PLAN-007599

Proposal: Two storey extension to an existing care home for the elderly building and additional car park. Single storey extension of main entrance and sunroom area.

Site: 216 Stakes Hill Road, Waterlooville, PO7 5UJ.

APP/14/00817

Screen Print

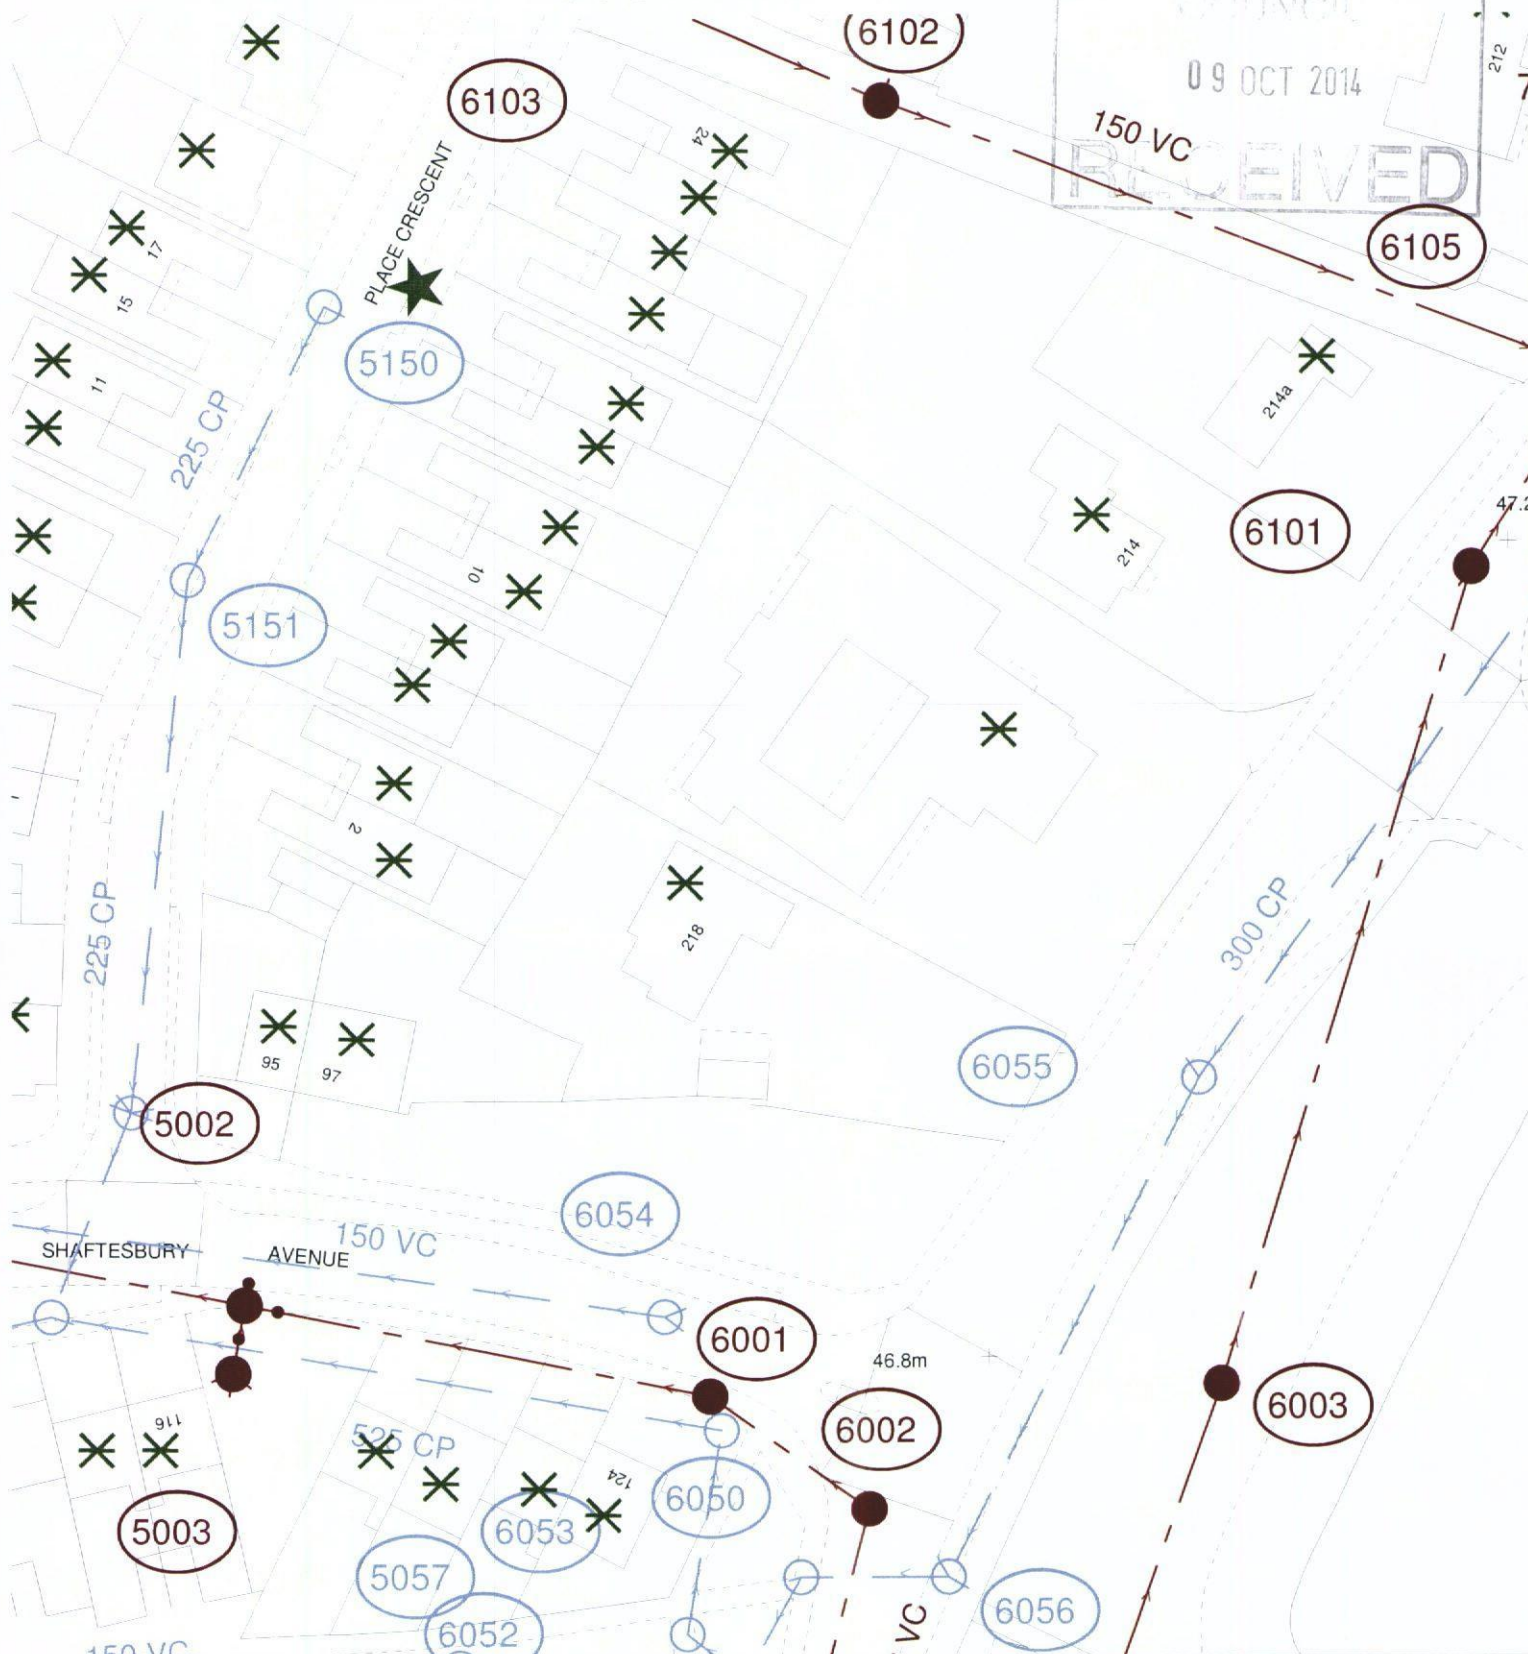
Due to changes in legislation that came in to force on 1st October 2011 regarding the future ownership of sewers it is possible that a sewer now deemed to be public could be crossing the above property. Therefore, should any sewer be found during construction works, an investigation of the sewer will be required to ascertain its condition, the number of properties served, and potential means of access before any further works commence on site.

The applicant is advised to discuss the matter further with Southern Water, Sparrowgrove House, Sparrowgrove, Otterbourne, Hampshire SO21 2SW (Tel: 0330 303 0119) or www.southernwater.co.uk.
